# Creating a Robust LRM Standard

January 12, 2006

# Comment Summary

# Launch Specifications

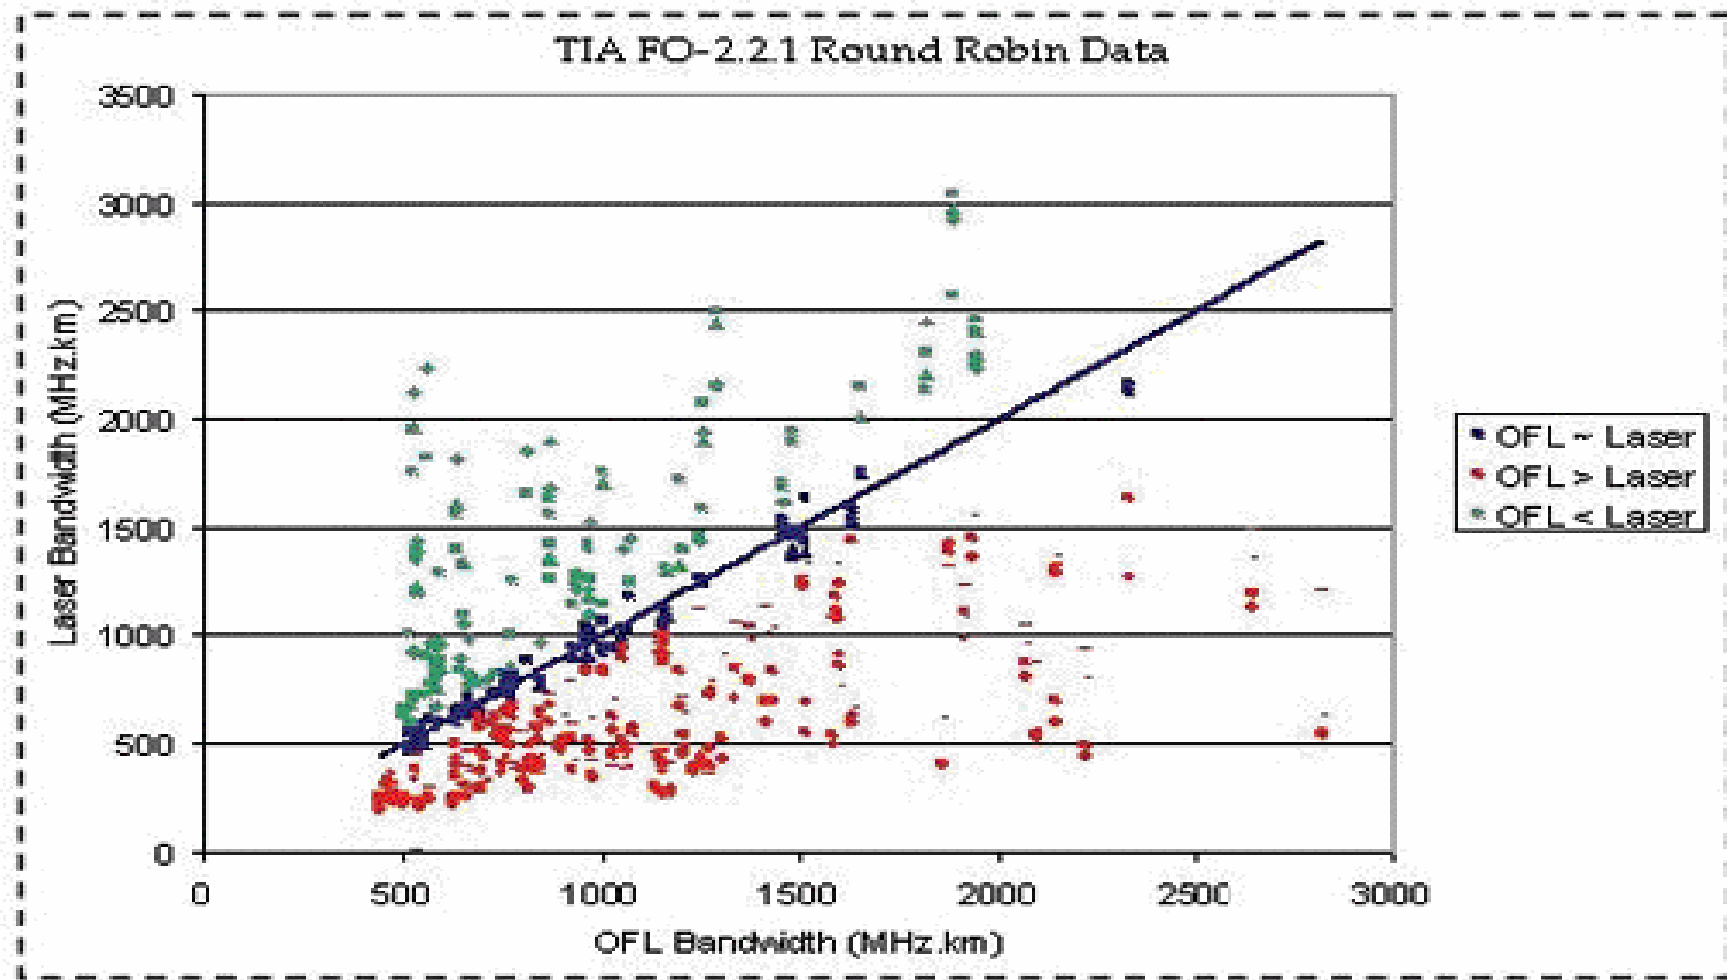
- 1000BASE-LX specifies a single launch, the MCPC, to support the specified data rate and link length
- 10GBASE-LX4 specifies a single launch, the MCPC, to support the specified data rate and link length
- LRM specifies two launches, a preferred launch, the MCPC, and an alternative launch, the CL
- OM1 and OM2 are not specified to support center launches
- MCPC has been proven and “guarantees” a minimum effective modal bandwidth for laser based systems
- Why are we going away from a proven and accepted launch already specified in previous standards?

- I am recommending that 802.3 specify a single launch for each fiber type
  - Offset launch for OM1 and OM2
  - Center launch for OM3
- Resolution covers comments 46, 49, 51 and 72-76
